Project	Creekview Ranch School Campus Expansion – Site Package
Client	Dry Creek Joint Elementary School District
Date	07/21/2026
Project Number	Y2514.00
Agency Number	02-123892 Inc. 01

End of Addendum Number 03

C2.2
AD3.07

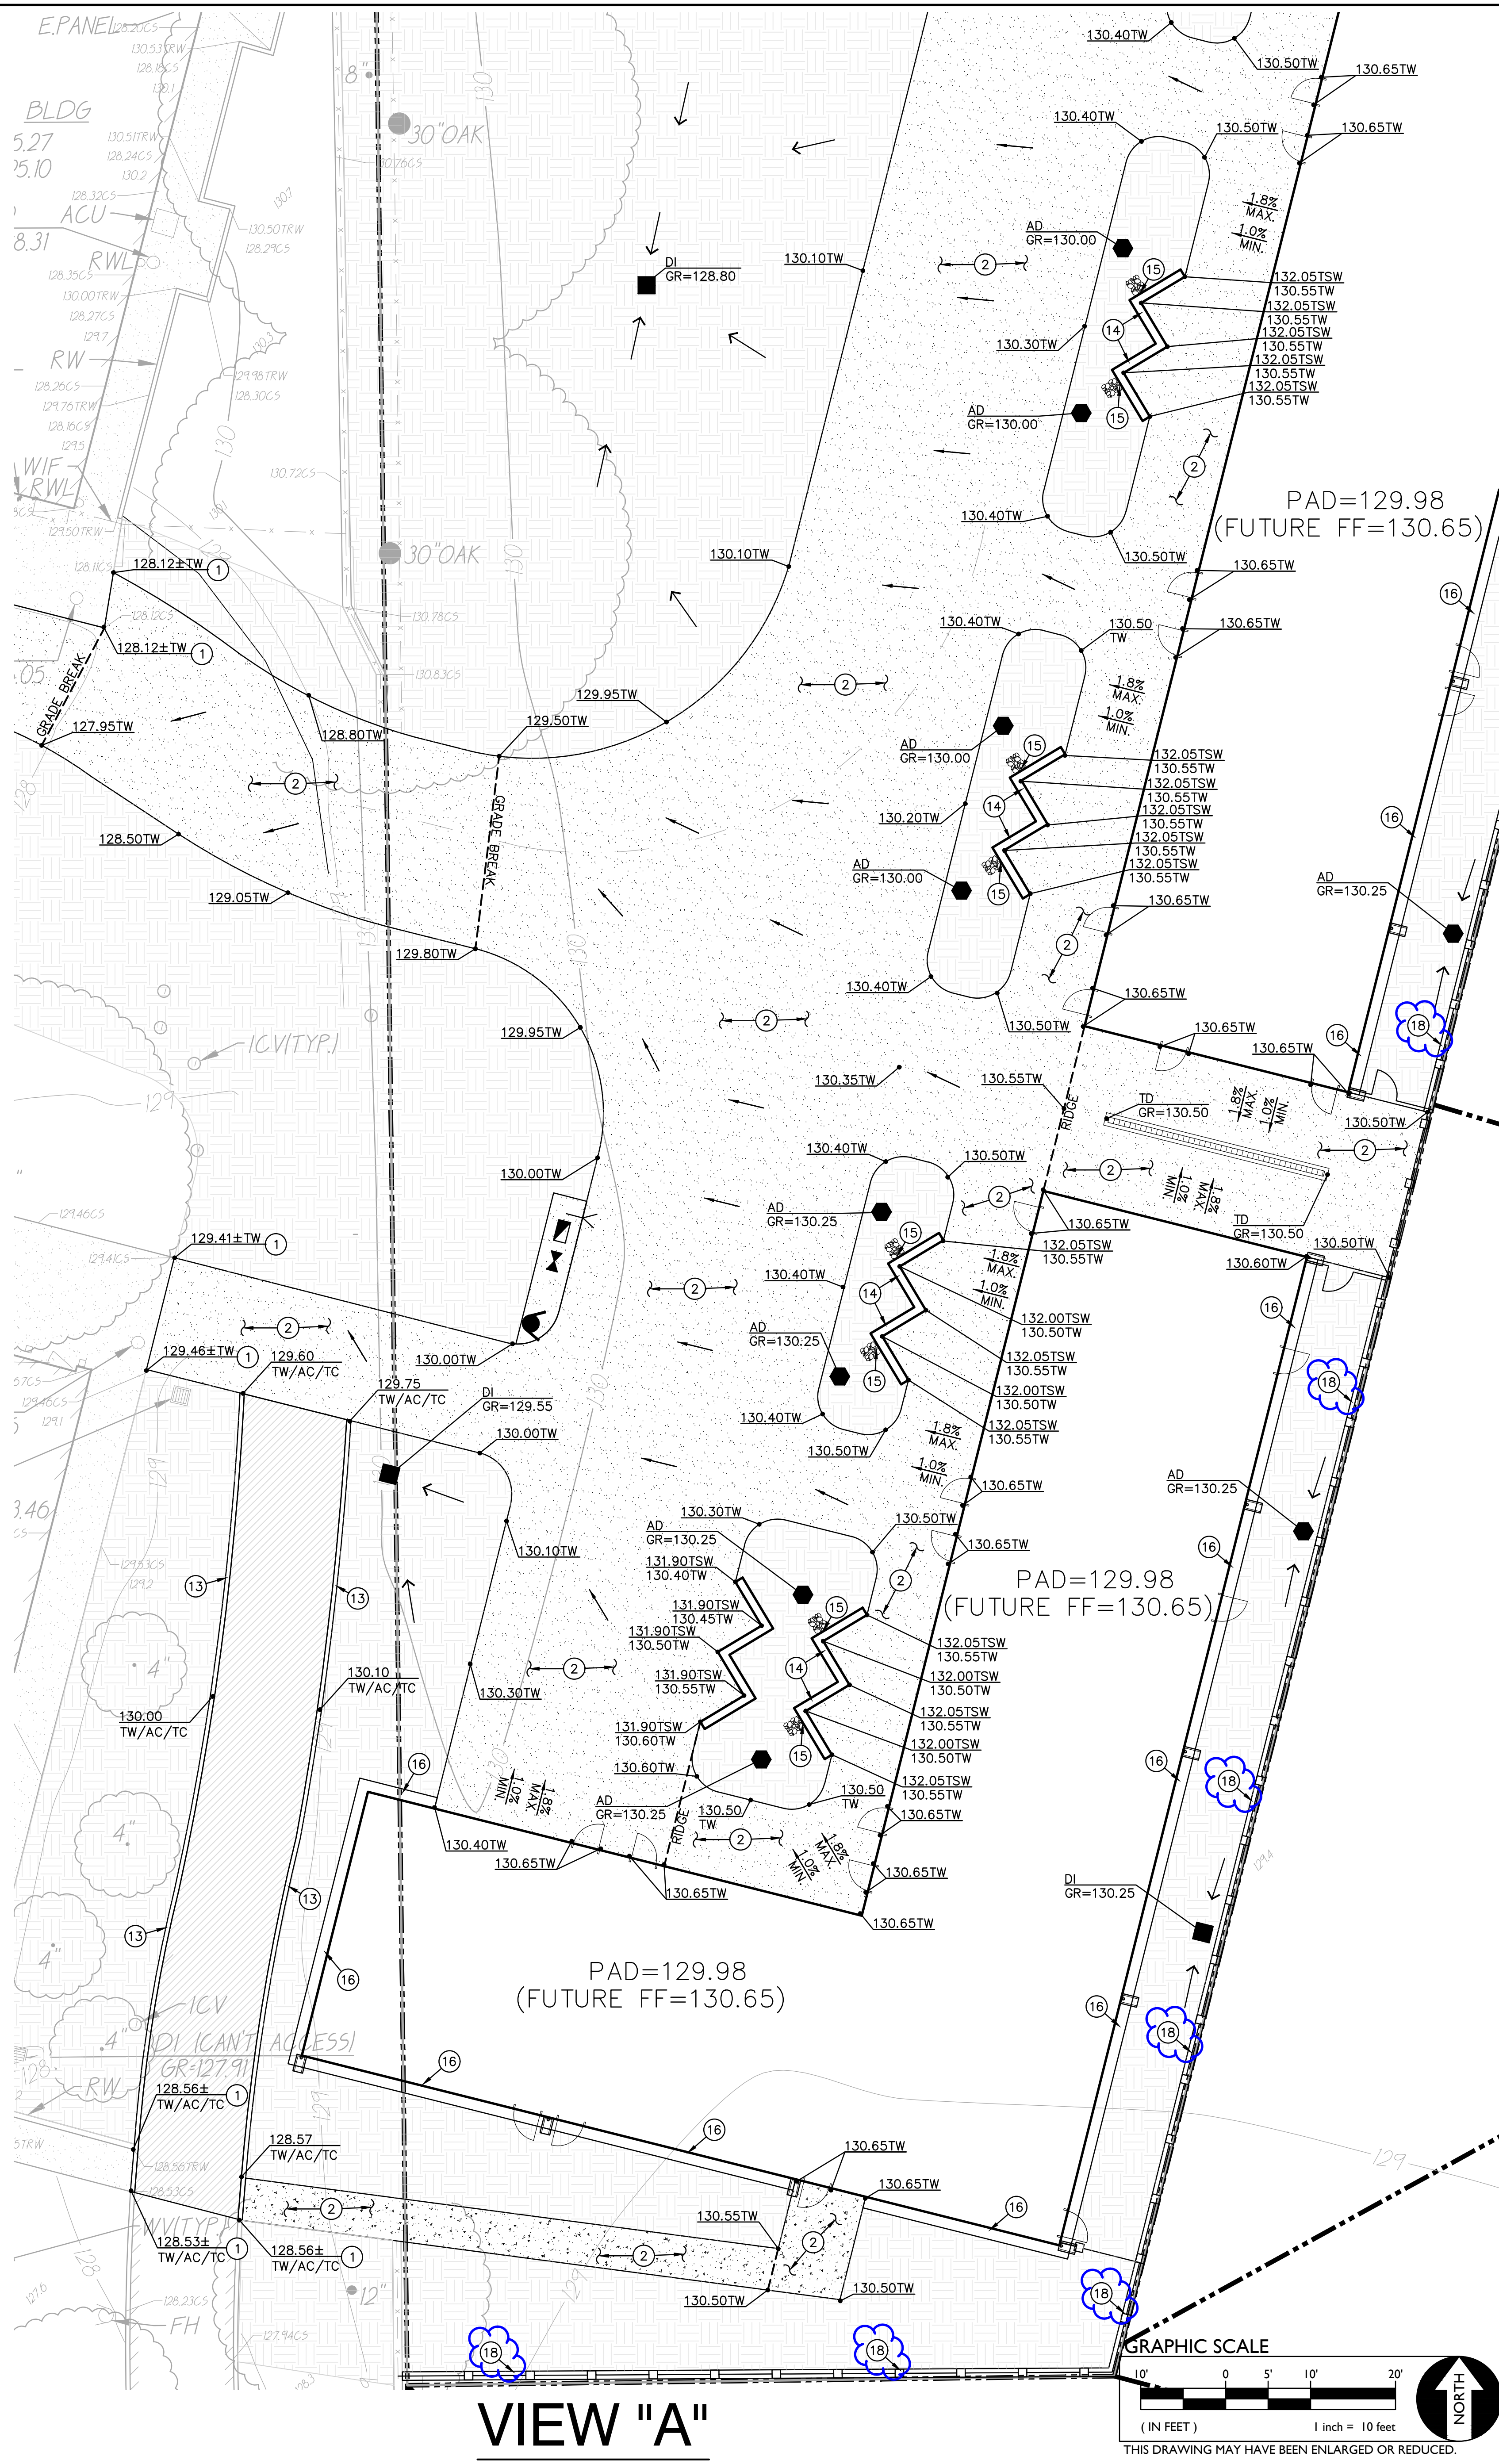
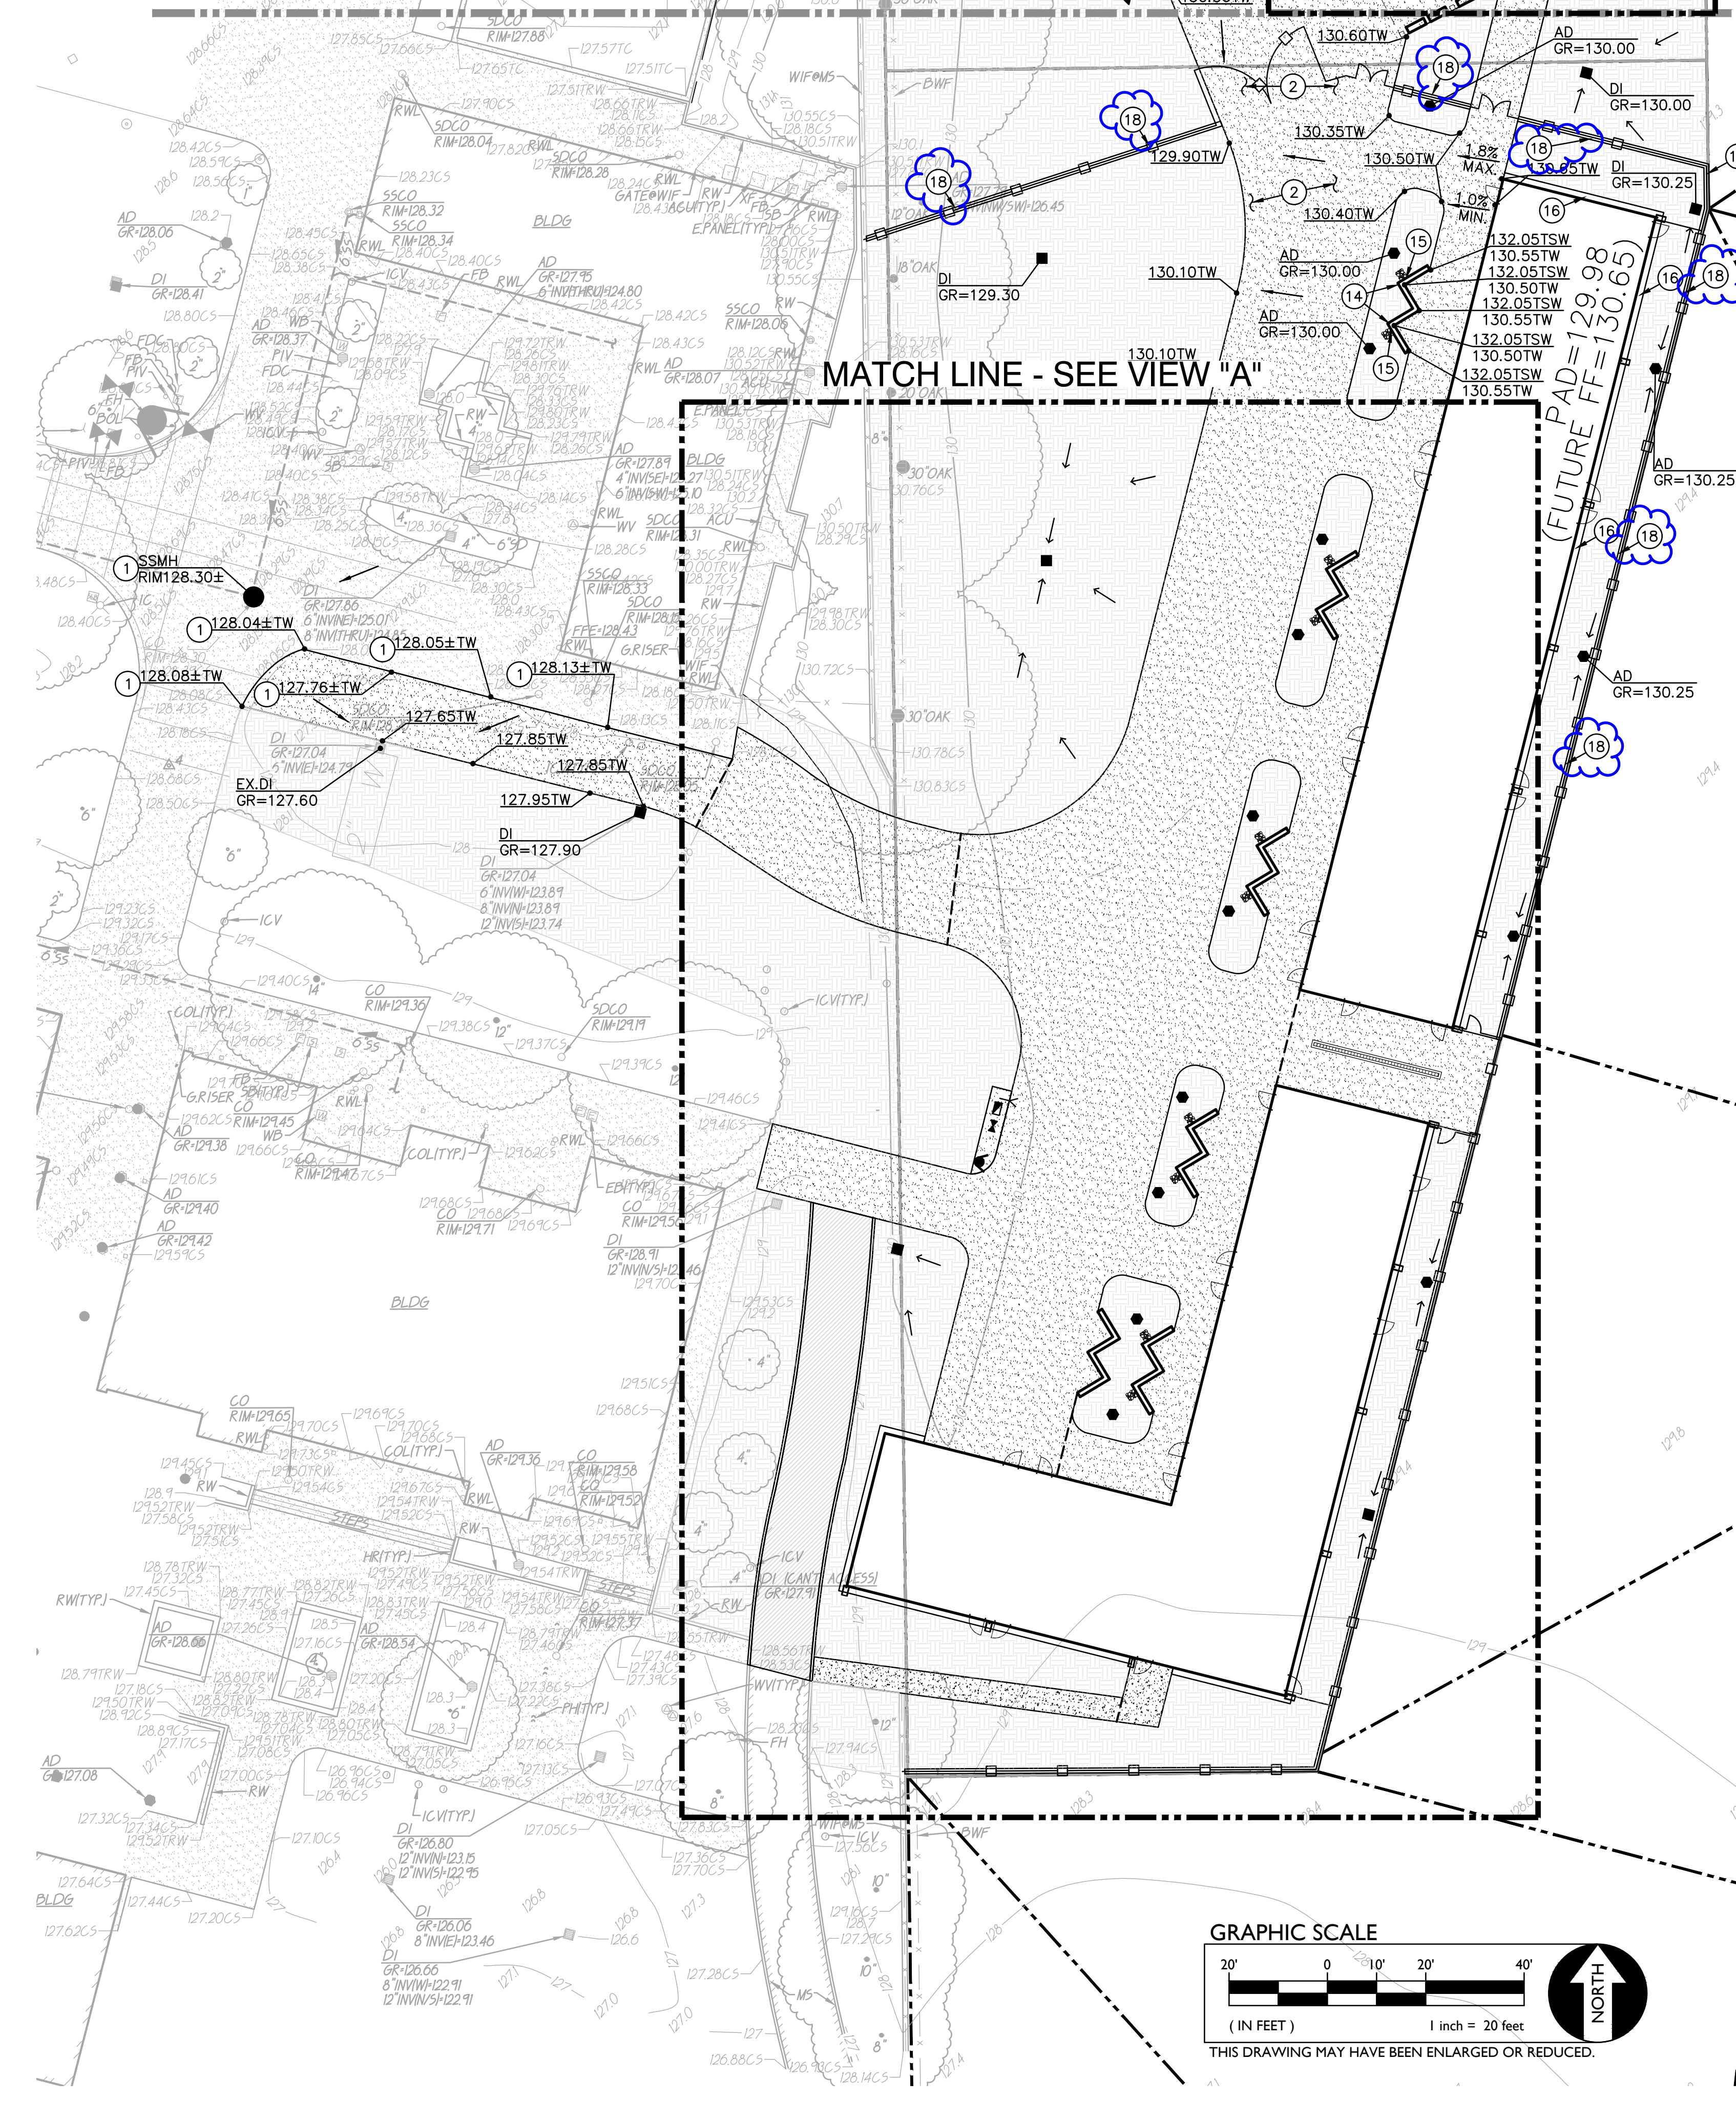
Q#1: Detail 9/A105 calls for out "mow strip per 13/C6.1 where occurs on plans". Sheet C6.1 is the erosion control plan and doesn't have a detail 13. We're assuming a mow strip is required under the new fencing to match existing conditions. Please confirm a mow strip is required under all new fencing and provide detail.

R#1: New mow strip is required under new fencing in some areas – keynote 18 was added on C2.1 and C2.2 to show locations of new mow strip and Detail 15/C7.2 been added, see attached sheet.

- AD3.07** Sheet C2.2 – Grading Plan
 - Added Keynote 18 and placed on all views
- AD3.08** Sheet C3.2 – Utility Plan
 - Added detail references for keynotes 41, 41, and 44, and added sewer note 55.
- AD3.09** Sheet C7.2 – Details
 - Added details 15, 16, 17, and 18.

C3.2
AD3.08

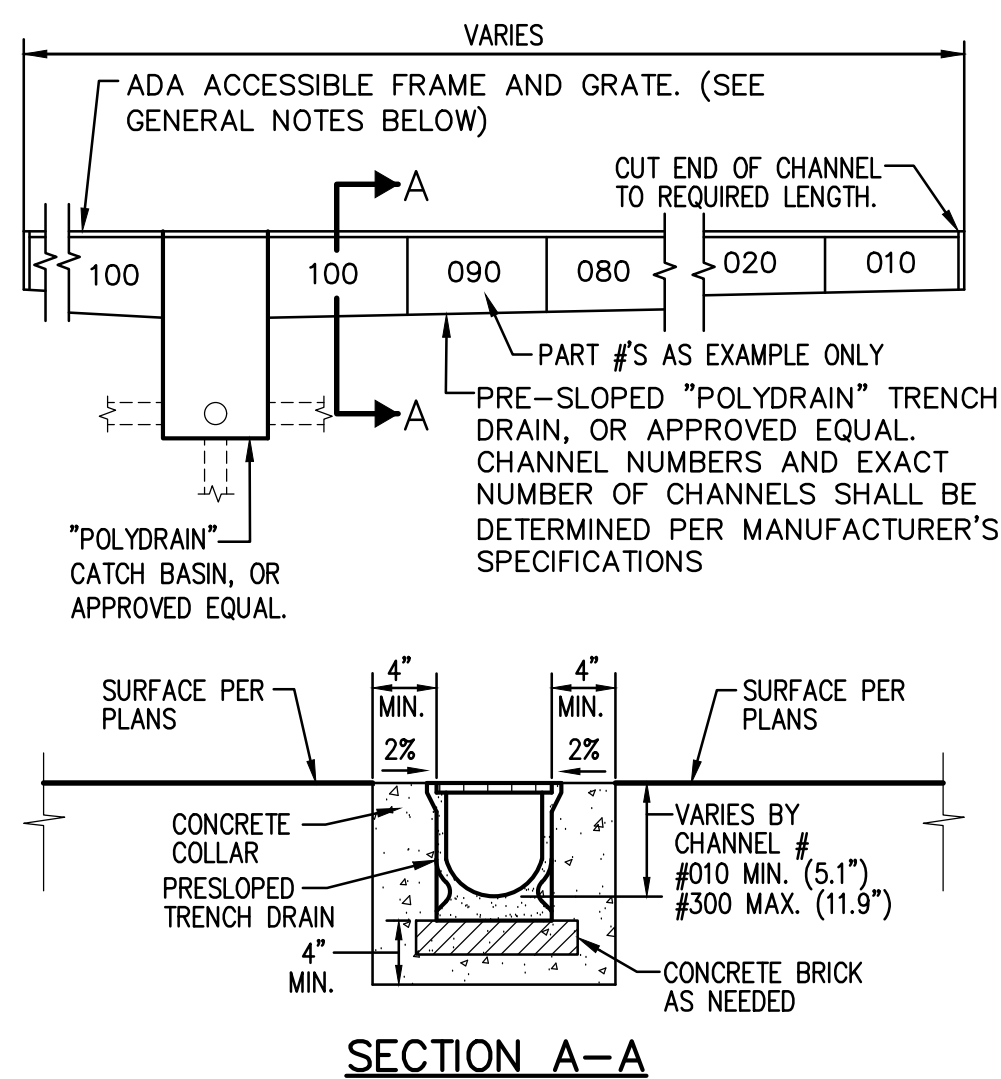
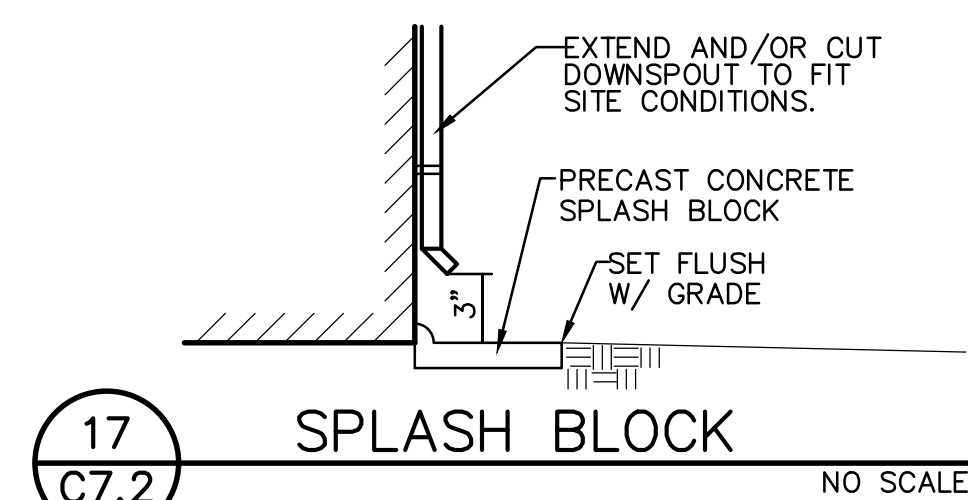
Q#5: Please provide a detail for the downspout to storm drain connection per note #41 on sheet C3.2

Q#6: Please provide a detail for the splash blocks, reference drainage note #42 on sheet C3.2

Q#7: Please provide concrete & connection details along with manufacturer model & grate type for the trench drain shown in between the new buildings on sheet C3.2
